The Examiner indicated that the drawings filed on April 30, 2001 are objected to because reference numerals 48, 48a and 48b; 101, 117a and 117b; 118, 118a and 118b are not found on the figures. Also, reference number 314 on Fig. 32 is not found in the specification. Further, pins D and G are not labeled in Fig. 33. The Examiner requested proposed drawing corrections or corrected formal drawings in reply to the office action.

Applicant has amended Fig. 3 to depict reference numbers 48, 48a and 48b as described on page 11 of the specification. Applicant has amended Fig. 14 to depict reference numbers 101, 117a and 117b as described on page 14 of the specification. Applicant has amended Fig. 11 to depict reference numbers 118, 118a and 118b as described on page 15 of the specification. Reference number 314 on Fig. 32 has been deleted. Fig. 33 has been amended to depict pins D and G as described on pages 22-24 of the specification. Informal drawing sheets having the above amendments highlighted in red ink according to MPEP § 608.02(v) are included herewith. No new matter has been entered as a result of these amendments.

FIG. 27

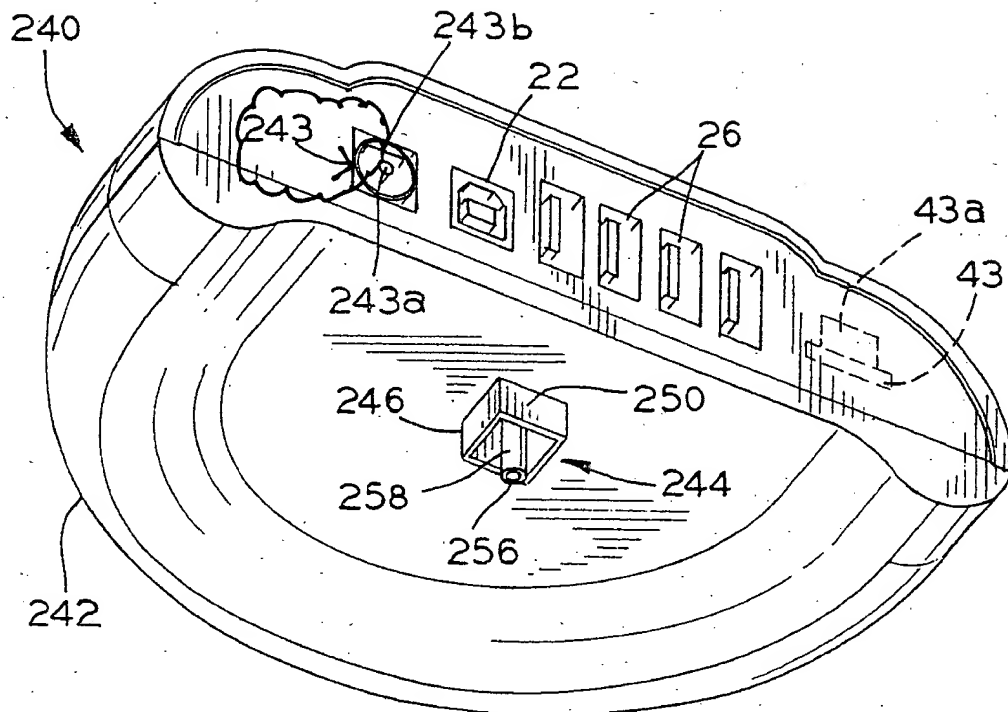
Applicant noticed the following items which also require correction. Applicant has also added reference number 80 to Fig. 14 as supported in the specification. An arrow has been added to the leader line for reference number 243 on Fig. 27. Fig. 32 has been amended to more accurately depict a preferred embodiment of applicant's invention. Informal drawing sheets having the above amendments in red ink are included herewith. No new matter has been entered as a result of these amendments.
